Section 16 Planning Application for Proposed Minor Relaxation of Domestic Plot Ratio and Building Height Restrictions for the Permitted Residential Development with Commercial / Retail uses of the URA Ma Tau Wai Road/ Lok Shan Road Development Project (KC-020), and Proposed Public Vehicle Park
Planning Application No. A/K10/280

- Submission of Response-to-Departmental Comments -

Response to Departmental Comments Table

NOTIONAL SECTION PLAN

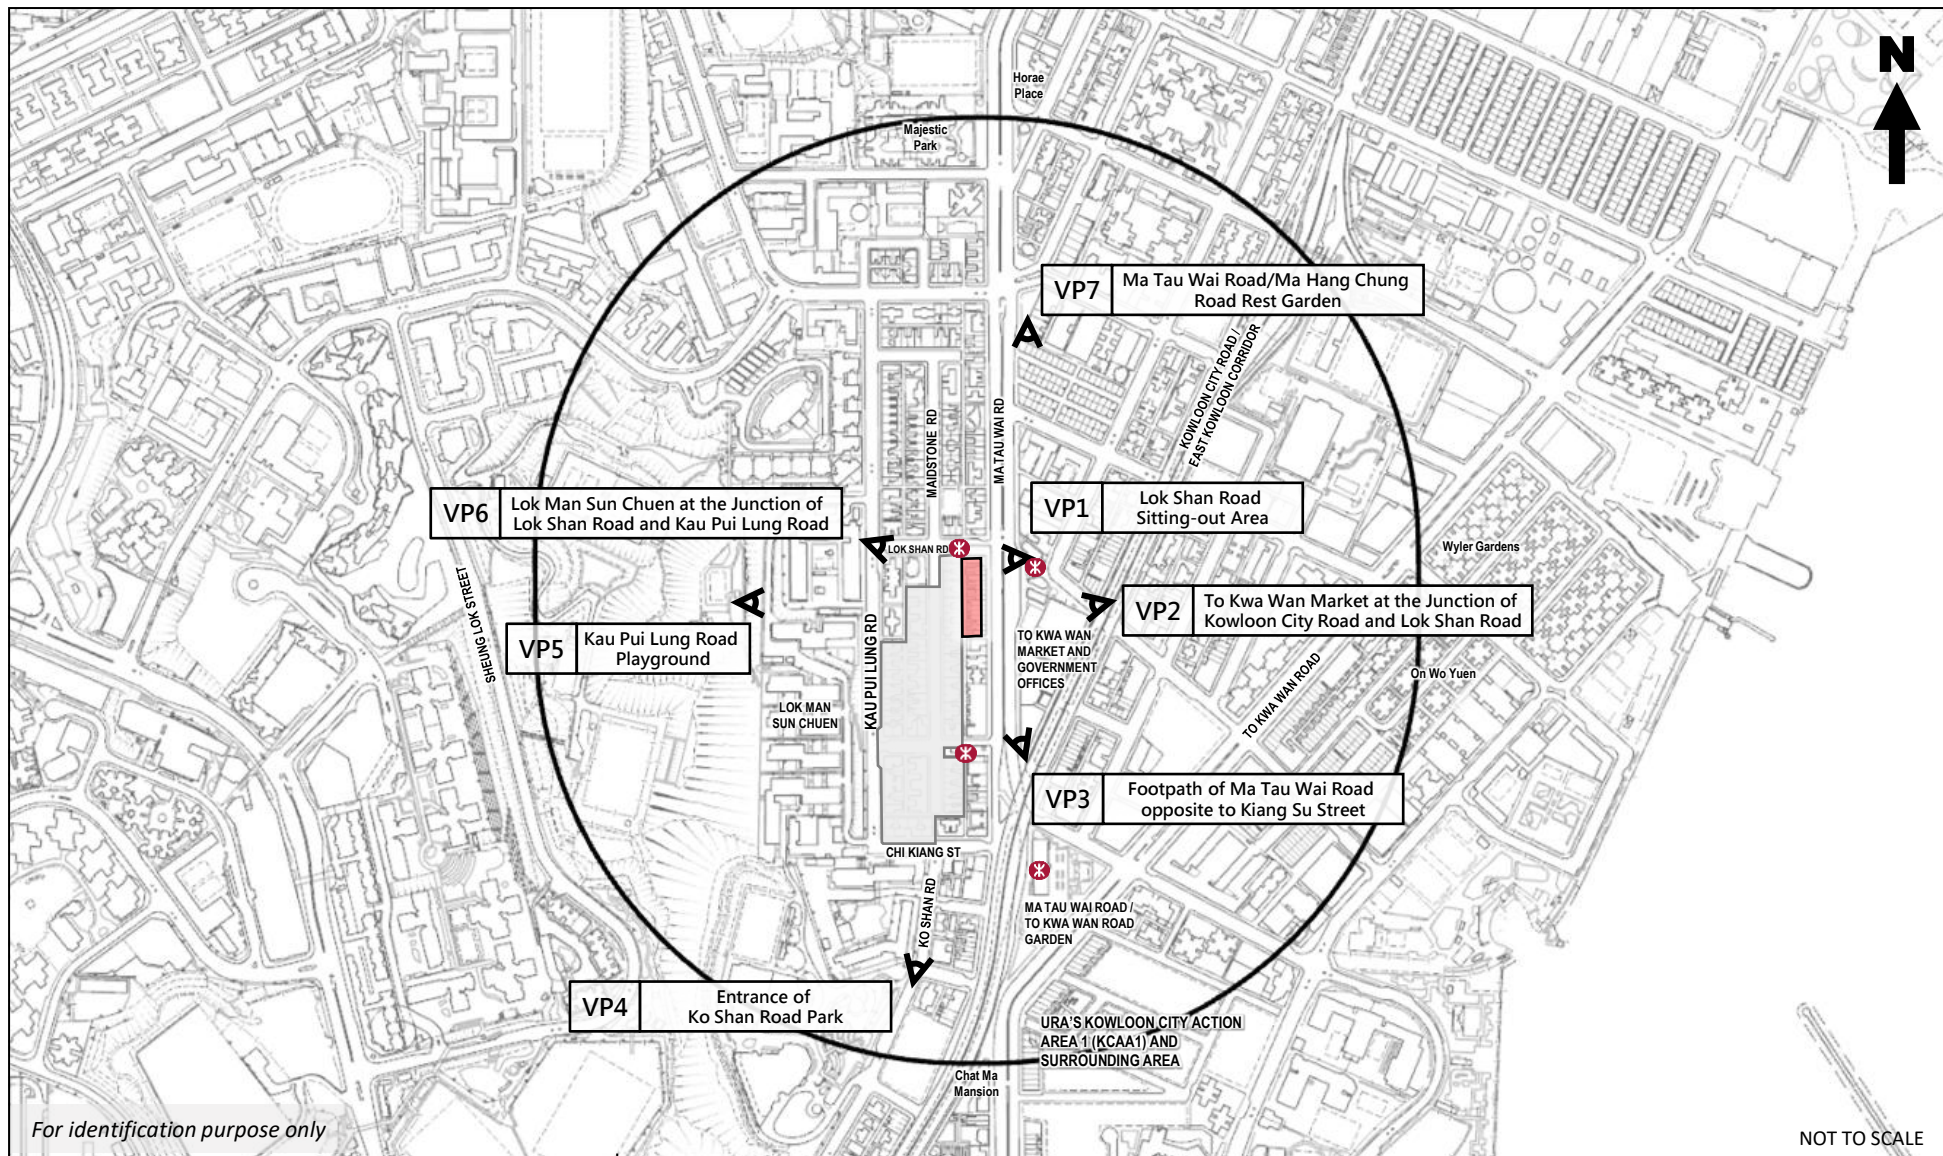
4. Floor-to-Floor Height (FTFH) According to Figure 3.2, the typical floor-to-floor height (FTFH) proposed for the indicative scheme is 3.3m to 3.5m, stated to be consistent with private residential developments in Hong Kong. Given that an FTFH of 3.15m or below is typically adopted across the industry including in several URA projects; please provide examples of developments that support your proposed 3.3m to 3.5m range.	The proposed typical FTFH of 3.3m to 3.5m has taken reference to many recent residential developments in HK, examples including the following private residential developments in To Kwa Wan: • 80 Maidstone Road (翰畋), located to west of the Application Site, with a typical FTFH of 3.3m; • The Vantage (啟岸), located at 63 Ma Tau Wai Road, with typical FTFH of 3.5m; and • Highwood (壹沐), located at 70 To Kwa Wan Road, with a typical FTFH of 3.3m. Besides, the following developments in other districts also adopt similar high ceilings, examples include: • One Park Place (柏景峰), Yau Tong, with typical FTFH of 3.3m; and • The Paddington (曉柏峰), Cheung Sha Wan, with typical FTFH of 3.5m.

8. Noting that there is a pedestrian connection to the south of the Site between Ma Tau Wai Road and the adjoining CBS-2:KC site, please provide the relevant dimensions (i.e. in terms of width and height) and indicate on the relevant block and section plans.	With the aim of enhancing the walkability and accessibility of the area, the Project will provide a pedestrian connection linking Ma Tau Wai Road to the Public Open Space (POS) and at-grade pedestrian avenue/event plaza network planned under the approved DSP of CBS-2:KC to create a cohesive and integrated spatial network for the two projects. The proposed pedestrian connection, as indicatively shown in the Notional Design under Figures 3.1 and 3.2 of the replacement pages of the Planning Statement in Appendix 1, are not drawn to scale, it is approximately 10m (width) x 8m (height) subject to detailed design.

PHOTOMONTAGES OF VP1 (Lok Shan Road Sitting-out Area)

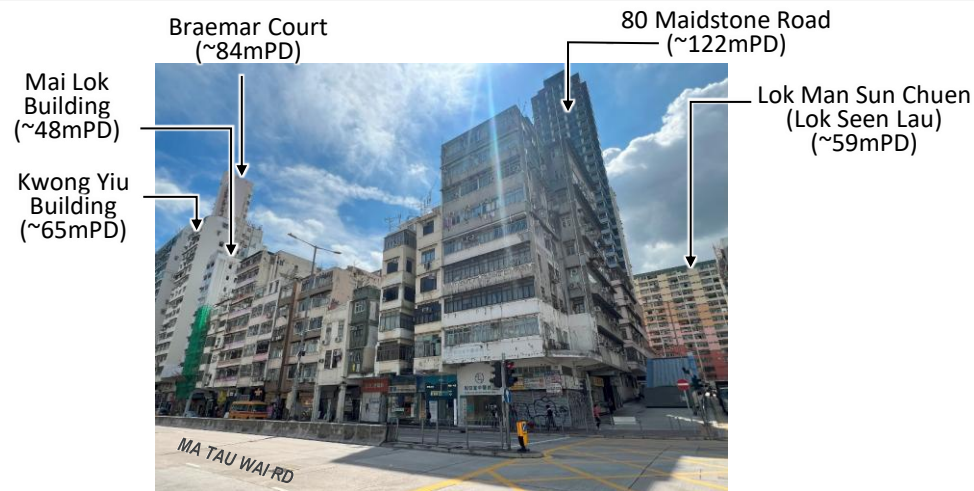
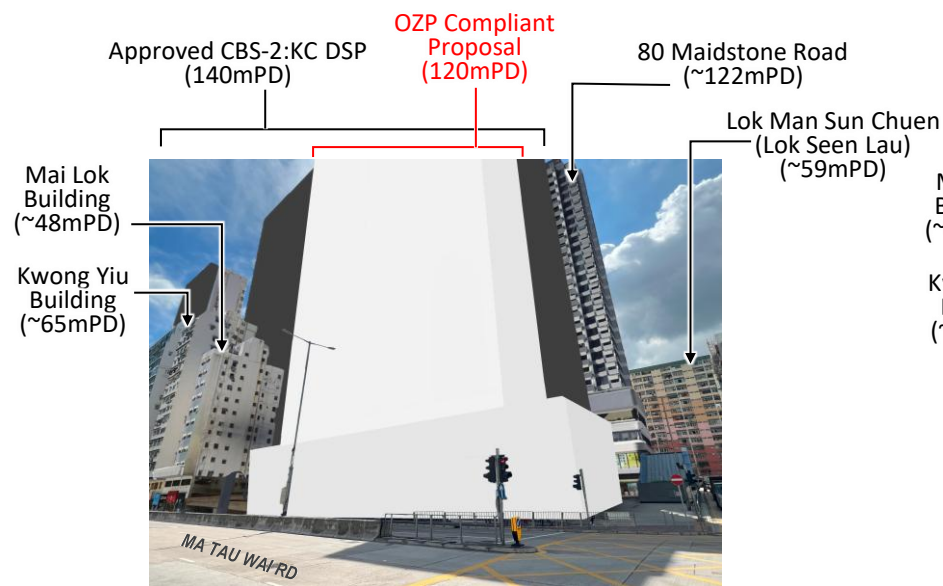
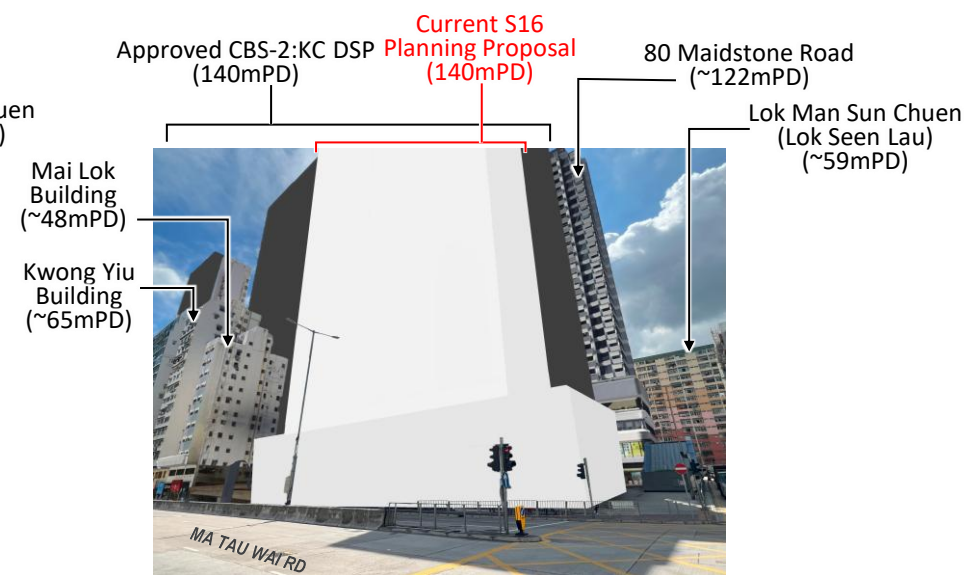
9. Figure 5.1 (VP1) – the proposed development under the OZP Compliant Scheme and the Proposed Scheme should appear to be slimmer, and the podium should appear to be lower.	Noted. Figure 5.1 (VP1) has been updated and provided as replacement page of the VIA report in Appendix 3 .

PHOTOMONTAGES OF VP6

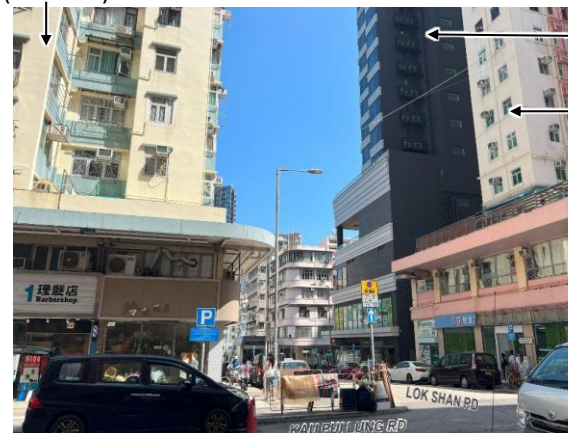
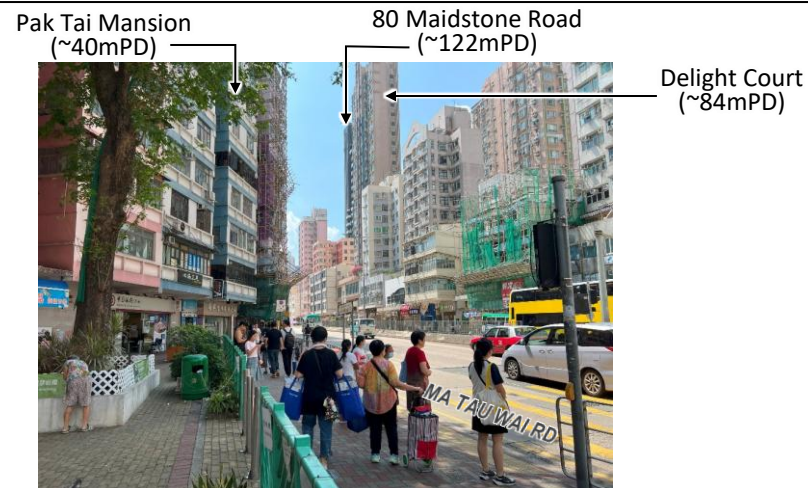
10. Figure 5.6 (VP6) – the proposed development would be completely screened off by the adjoining CBS-2:KC.	Noted. Figure 5.6 (VP6) and the corresponding "Appraisal of Visual Impacts of Selected Viewpoints" in Table 5.2 (VP6) have been updated and provided as replacement pages of the VIA report in Appendix 3 .
